Certificate of Appropriateness **AMENDED**

Property 1921 N. 2nd Street Brewers Hill Historic District
Description of work Whole House renovation
Date issued 1/16/2018 PTS ID 114448 COA New furnace venting

The Certificate of Appropriateness issued July 8, 2016 is hereby amended to reflect (1) the required correction to the cladding and trim material, (2) the new deadline date of March 20, 2018 and (3) submittal of plans for the new rear porch.

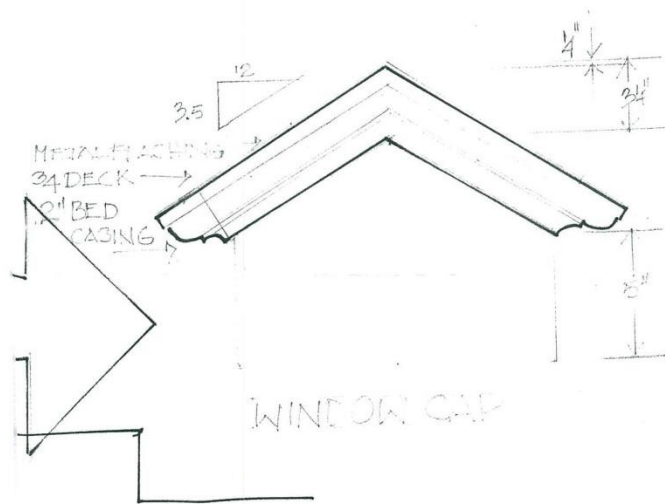
The condition of the house in the early 1980s.

The front door with transom was original until the 1980s and has been replaced. It is the intent to install a new wood door. The door will match this original and the transom will be retained.

House as it appears today.
Window tops will match the
design as shown below.

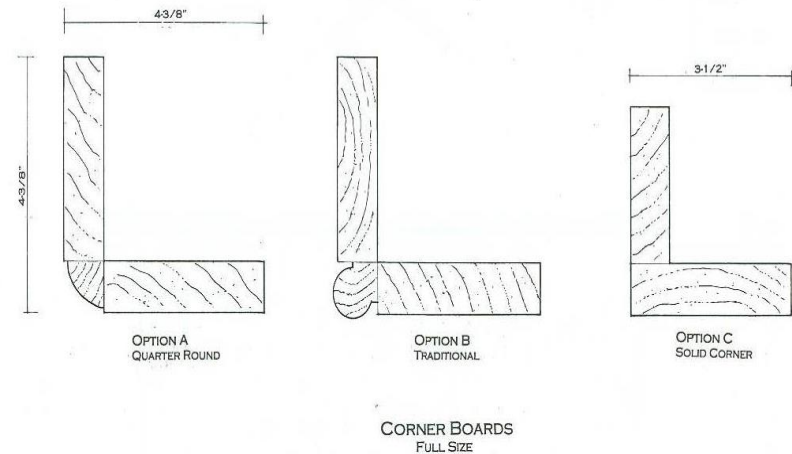
Clapboards will be replaced with new cedar siding. The Paulownia wood installed will be removed and cedar siding installed. Window trim and other trim must be cedar. Corner boards can be built according to one of the designs below.

Note 2-over-2 sash. Window tops should be crowned with moldings that will shed water as shown below.

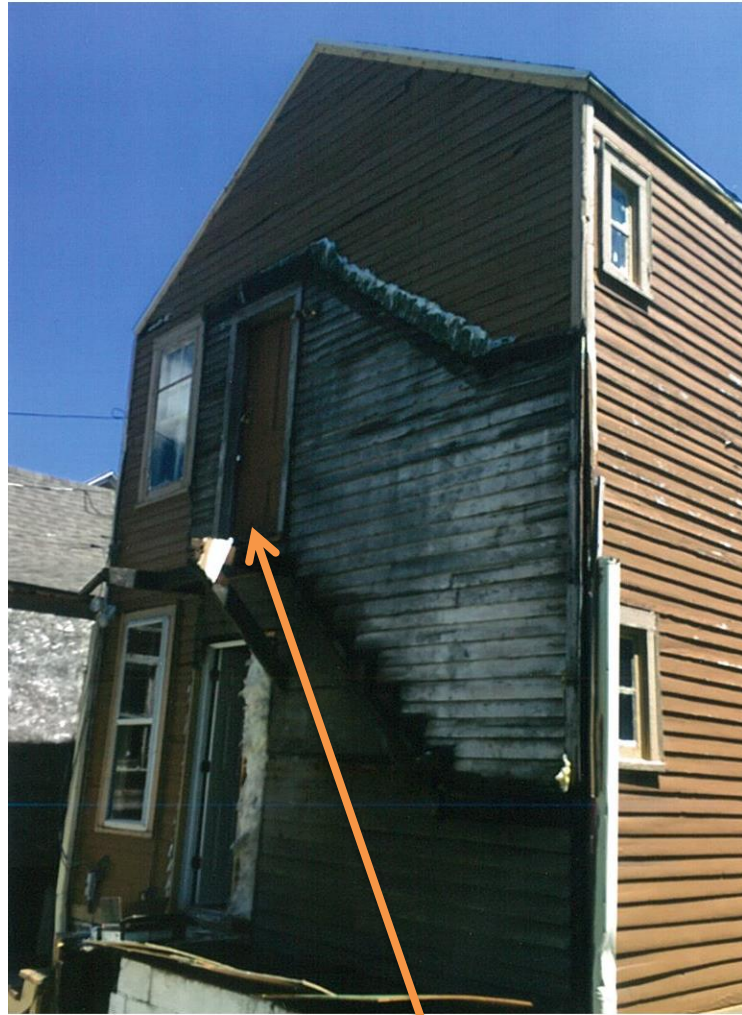
Water table will be added to help shed water

The rear stair enclosure as it looked in Mid-June 2016

The rear as it appeared after the enclosure was removed.
Note: the upper door will be eliminated.

New cedar clapboards will have same exposure as the originals

Doors

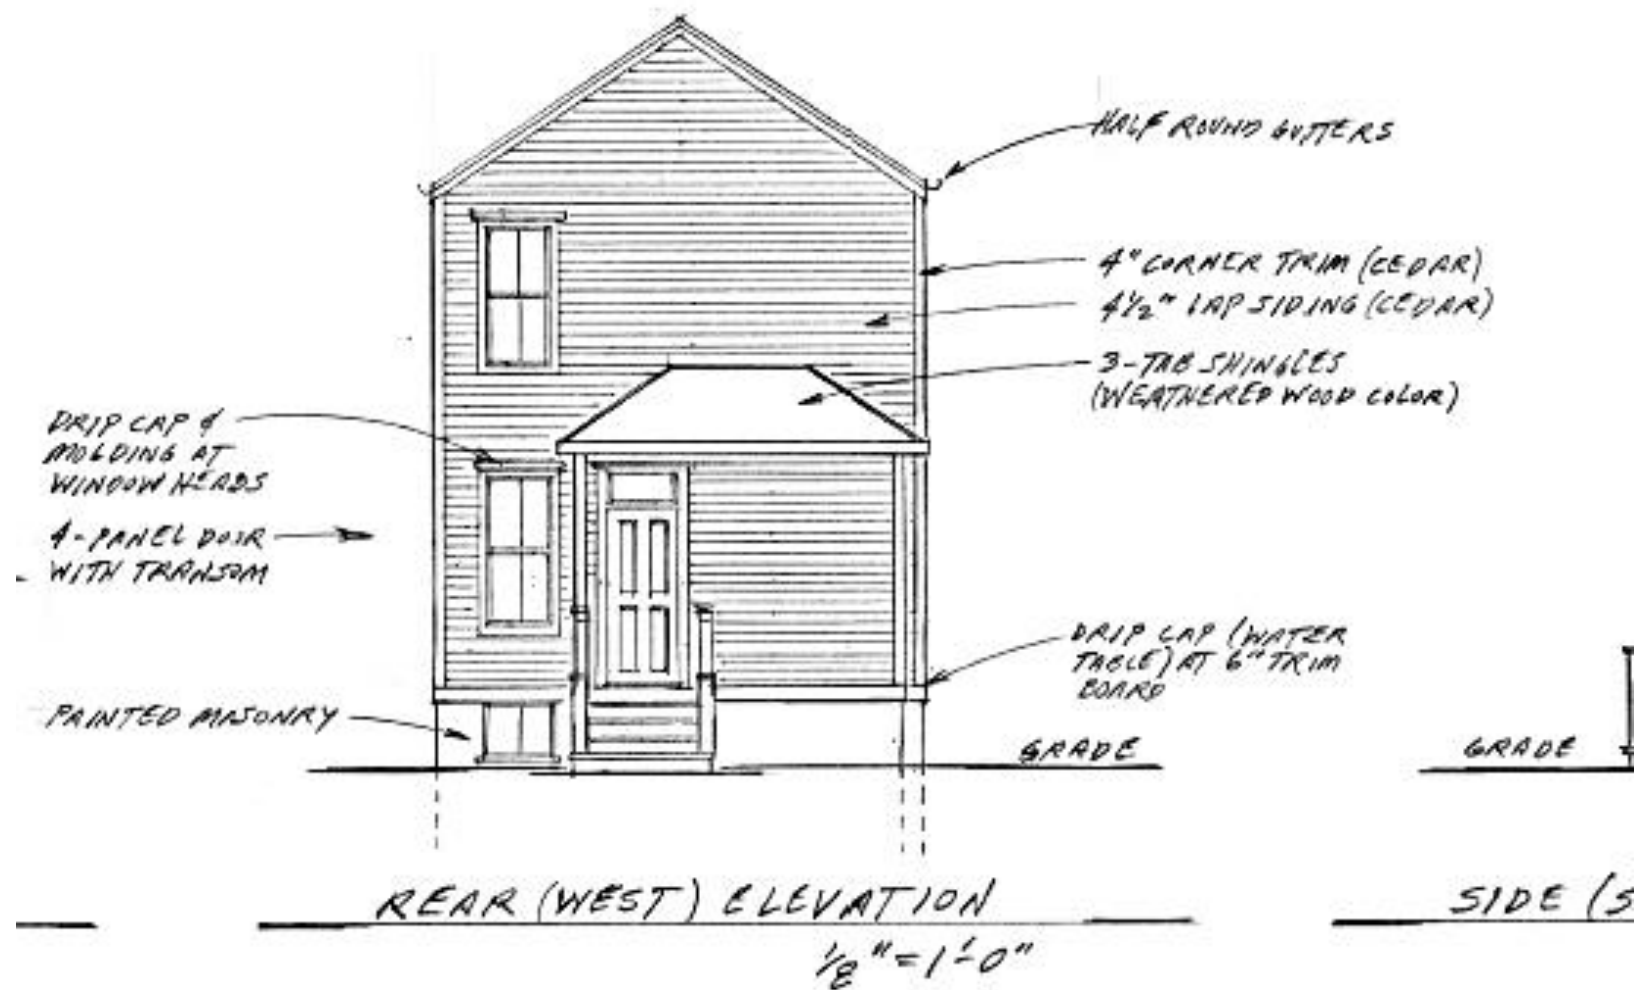
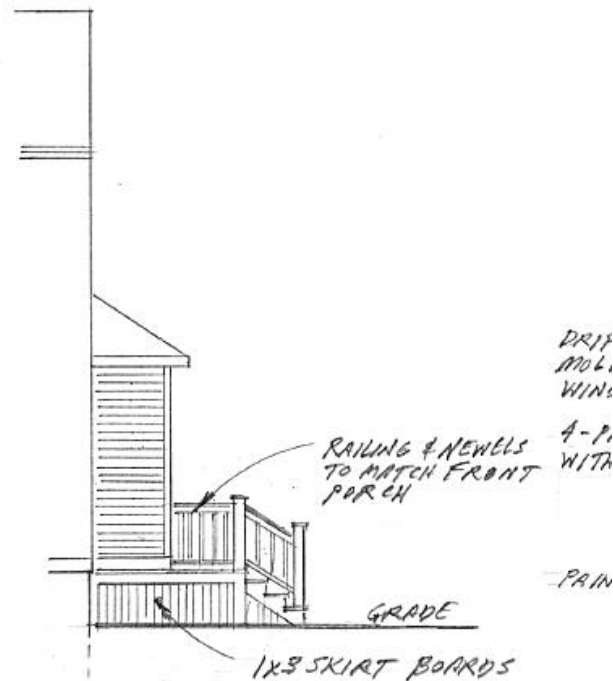
These three styles are appropriate for the rear door.

SIDE (NORTH) ELEVATION

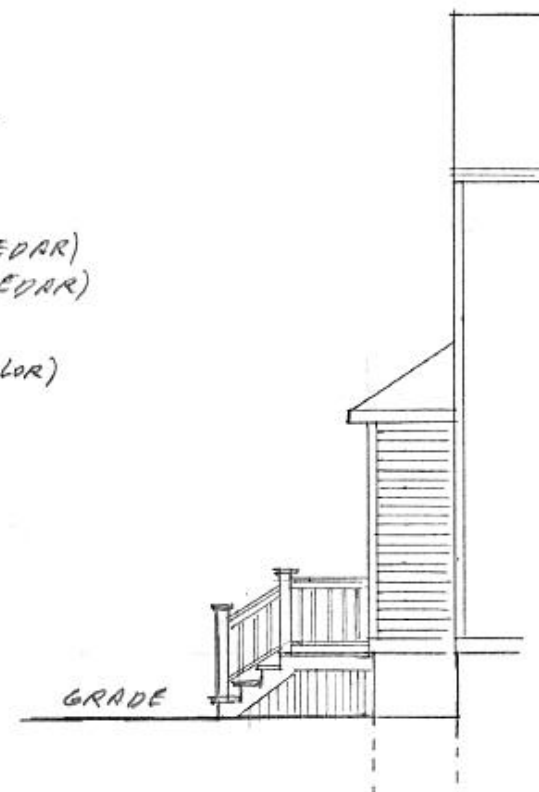
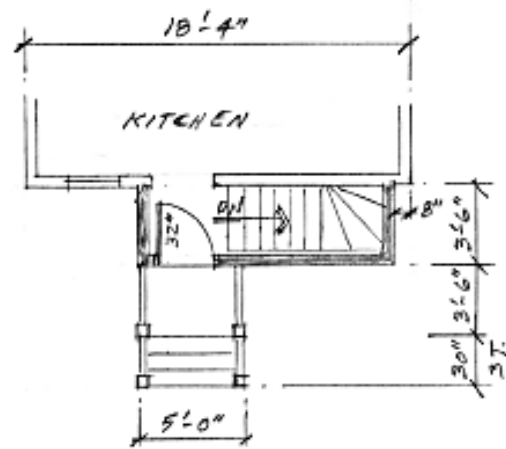
8) The new rear porch will be constructed as shown in the attached drawings. If code requirements necessitate alterations to the design, new drawings are to be submitted to HPC staff.

New rear porch with enclosure for exterior basement stairs.
